REQUEST

Proposed Zoning: UR-2(CD) (urban residential, conditional) with five-year vested rights.

Approximately 3.49 acres located on the east side of Park Road, north of Sharon Road.
 (Council District 6 - Bokhari)

The petition proposes redevelopment of four parcels containing three single family homes with a 20-unit, single family attached development along Park Road north of Sharon Road.

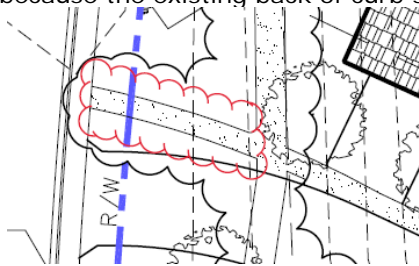
1. Remove the section of internal sidewalk, shown below, that is parallel to the northern most driveway between the proposed sidewalk along Park Road and the existing back of curb sidewalk because the existing back of curb sidewalk should be removed.
